Service Bulletin

PRE-MIXED LONG-LIFE "FL22" ENGINE COOLANT

Bulletin No: 01-002/16
© 2016 Mazda Motor of America, Inc.

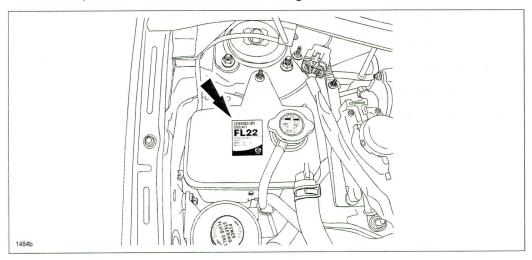
When coolant replacement becomes necessary for older Mazda models not originally filled with FL22 coolant, FL22 coolant can be used. If FL22 coolant is used for older models, be sure to place a FL22 sticker on the reserve tank or degas bottle to indicate FL22 coolant is being used. Six (6) FL22 stickers are included with each case of coolant.

- In the case of older models, the coolant replacement interval is every five (5) years or 60,000 miles.
- · FL22 coolant is compatible with current (Green) ethylene glycol coolant.
- If FL22 coolant is mixed with existing Orange coolant, coolant color will turn black. For customer satisfaction, DO NOT mix FL22 coolant and Orange coolant.
